Item 2.

Post Exhibition - Planning Proposal - Enterprise Area Review - Sydney Local Environmental Plan 2012 and Sydney Development Control Plan 2012 Amendment

File No: X025568

Figure 5: Proposed building height controls in the exhibited planning proposal

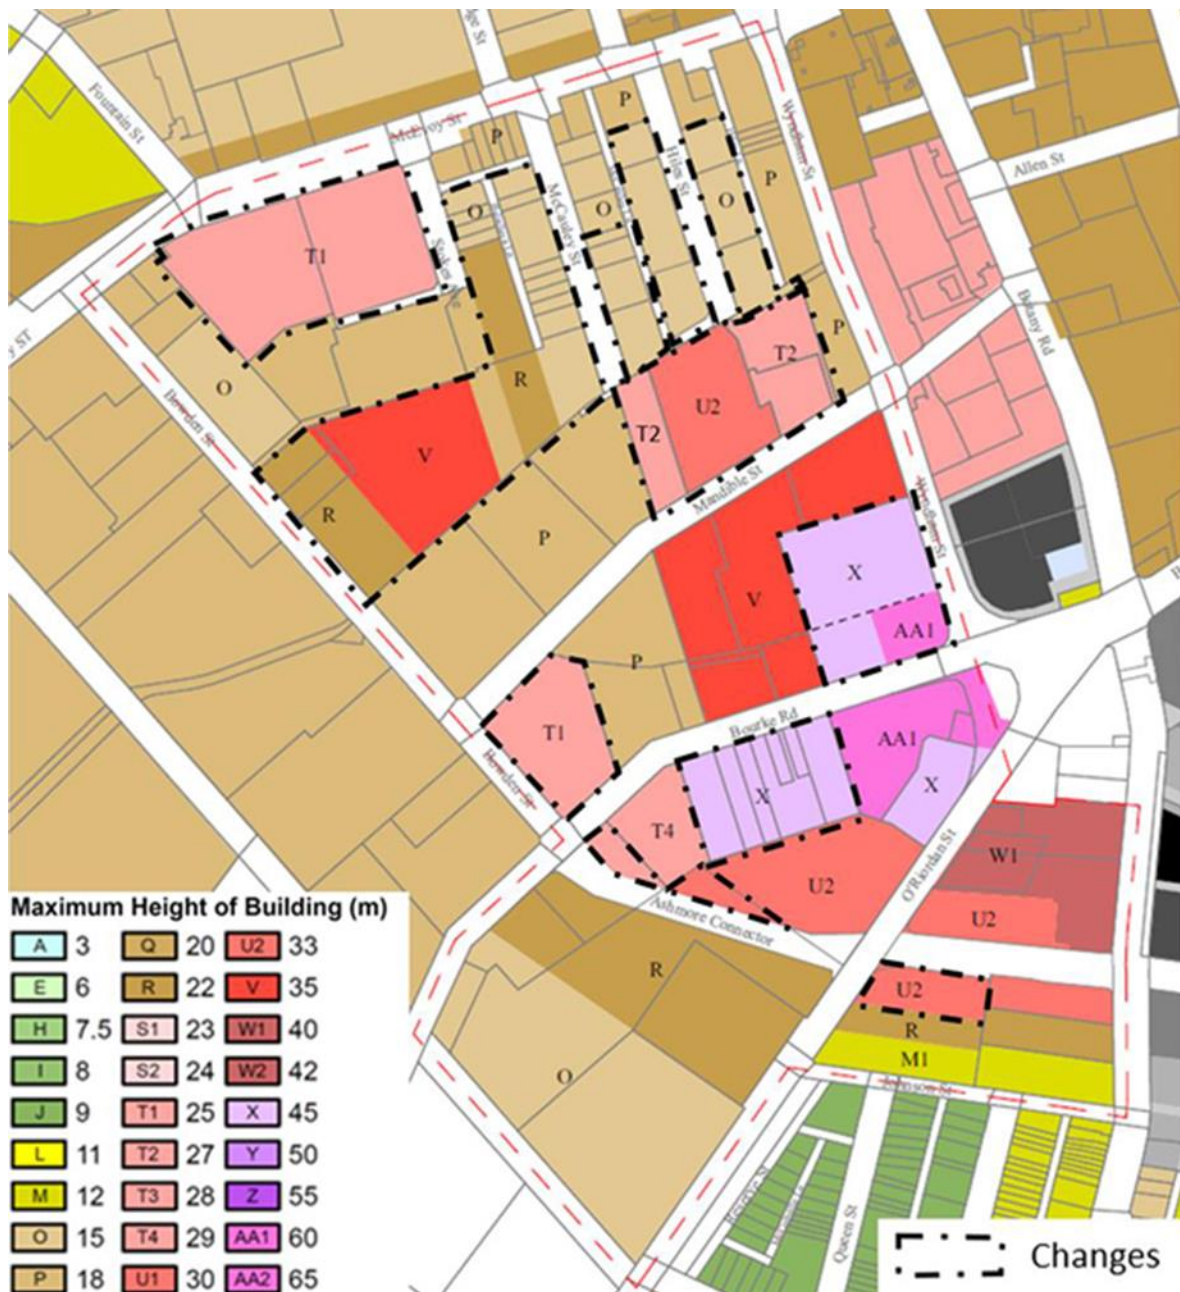
40. The proposed increase in building heights distributes floor space in North Alexandria without compromising the heritage character, amenity of surrounding uses and low scale residential and employment uses to the north and south. It will also facilitate better public domain and design outcomes, compared to outcomes that would be achieved under existing controls.
41. The proposed increase in building height in key locations provides the potential to unlock the applicable FSR control on sites and will enable the dedication of some of the land for new streets, setbacks and connections.

- 42. The proposed reduction in building height in the north-block from 18 metres to 15 metres responds to the existing built form context. Older industrial low scale warehouse buildings are located here, some within a heritage conservation area. The proposed controls also better align with the FSR controls applicable. A building height of 18 metres is retained for properties fronting the edges of the north-block along Wyndham and McEvoy streets.
- 43. Overall, amendments to building height will provide a better height transition within North Alexandria, and between North Alexandria and surrounding precincts.

190. On the publicly exhibited maximum height of buildings map in the planning proposal, the alignment of the road is also proposed to be corrected. The heights on the surrounding properties are to remain as shown in the body of the planning proposal report, which is shown at Figure 5 of this report. This is consistent with the urban design study that was exhibited with the planning proposal.

Figure 6: Proposed FSR controls in the exhibited planning proposal

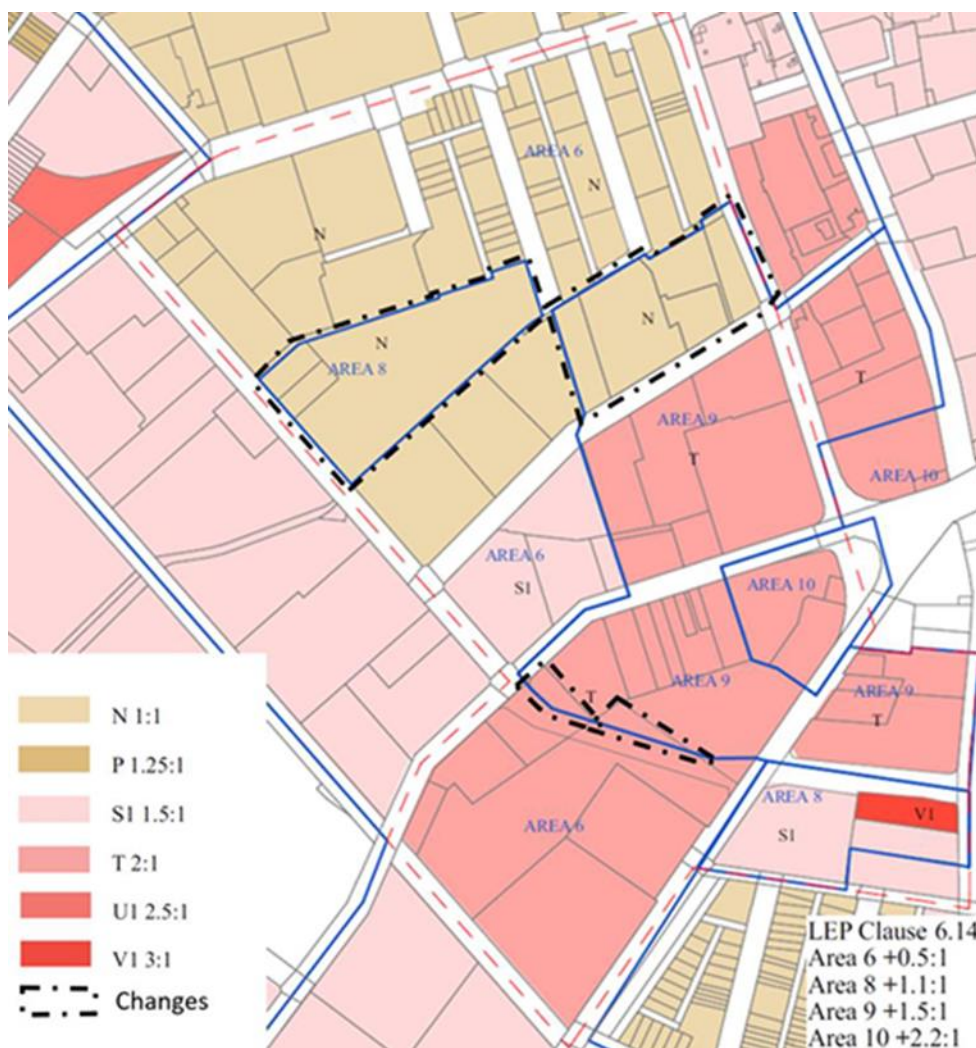
- 44. Figure 6 shows the proposed FSR map as it applies to North Alexandria. It responds to the unmet demand for floor space identified in the review and will allow for increased floor space within the area.

192. It is proposed to amend the FSR map so it shows the correct alignment of the northern boundary of the east-west connector road only, with the southern alignment of the road deleted. The FSRs on the surrounding properties are to remain as shown in the body of the planning proposal report (as shown at Figure 6 of this report). This is consistent with the urban design study that was exhibited with the planning proposal.

Figure 8: Sites where submissions from landowners were received

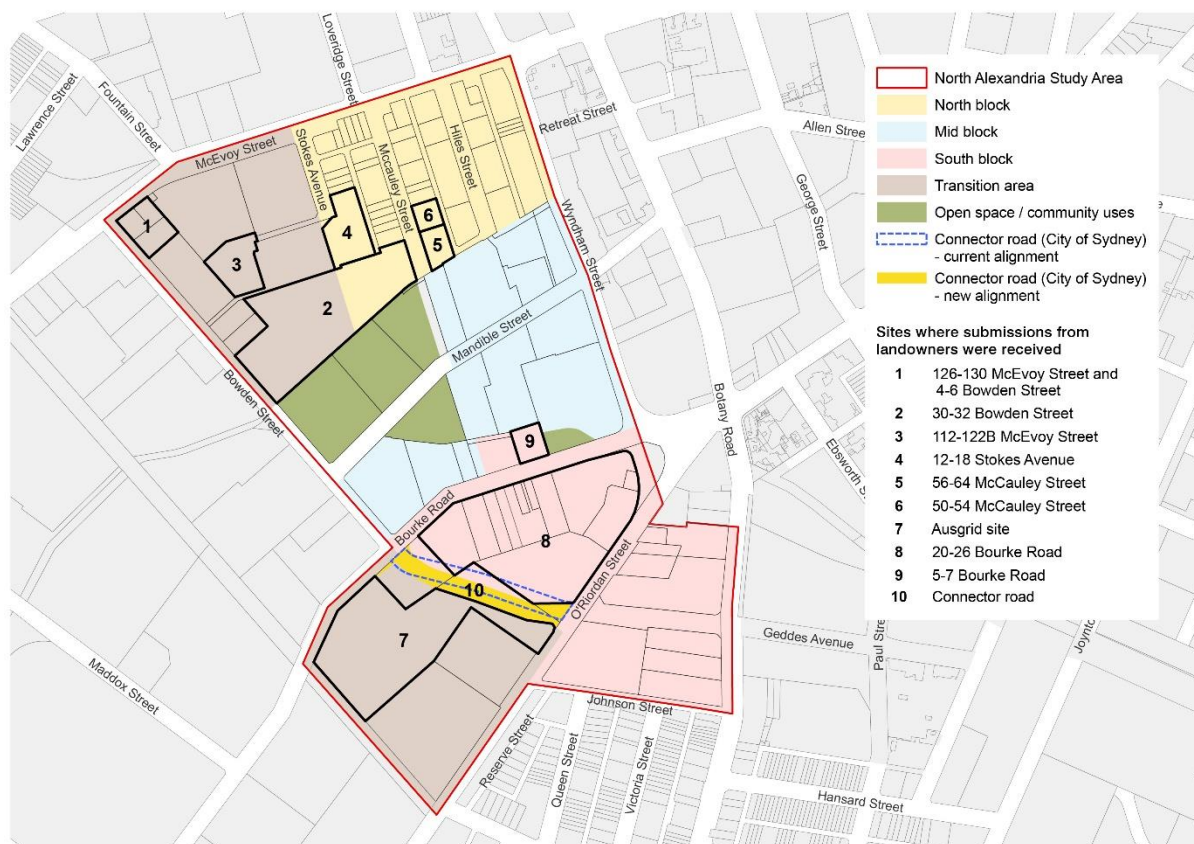
- 116. Landowners have generally been supportive of the vision for the precinct but have requested changes to the planning controls proposed for their sites, including increases to the building height, FSR or both in the planning proposal. Others seek minor changes to street wall height, setback or proposed controls in the draft DCP. Figure 8 below shows the location of the sites to which these submissions refer.

189. It is acknowledged the draft subdivision plan for the east-west connector road rests slightly south of the alignment shown in the exhibited draft DCP maps. It is proposed to amend this alignment in the draft DCP maps to show the correct location of the road. Refer to Figure 8, which illustrates the difference between the current and the new alignment.
